Service Bulletin

Bulletin No.: 19-NA-032

Subject: Lack of Power and/or Hesitation After Vehicle Has Reached Operating Temperature

Brand:	Model:	Model Year:		VIN:		Engine:	Transmission:
		from	to	from	to		
Chevrolet	Malibu	2018	2018			1.5L (LFV)

5225807

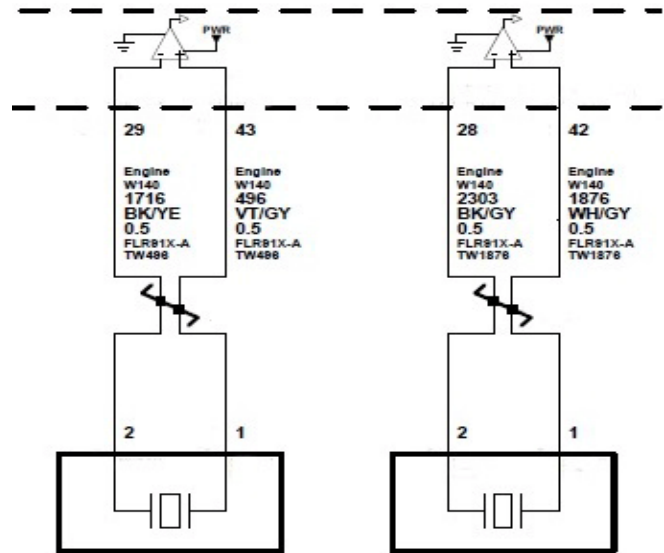
3. Disconnect all the ECM electrical connectors.
4. Remove the ECM and position aside.

5225787

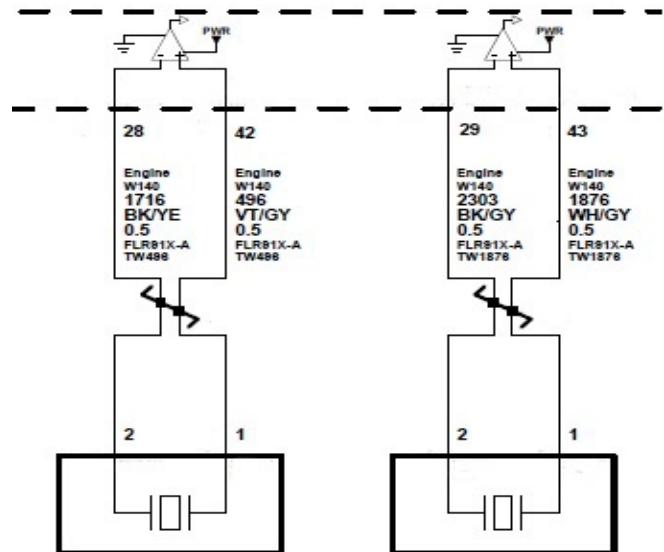
5. Locate cavity 28, 29, 42 and 43 at the X2 connector. Refer to Document ID#: 5067630.

6. Verify the following:
 - Cavity 28, BK/GY
 - Cavity 29, BK/YE
 - Cavity 42, WH/GY
 - Cavity 43, VT/GY
7. Remove pin 28 and pin 29.
8. Insert pin 28 into cavity 29 and pin 29 into cavity 28.
9. Remove pin 42 and pin 43.
10. Insert pin 42 into cavity 43 and pin 43 into cavity 42.

11. Verify the pins are in the new cavity as listed below:
 - Cavity 28, BK/YE
 - Cavity 29, BK/GY
 - Cavity 42, VT/GY
 - Cavity 43, WH/GY
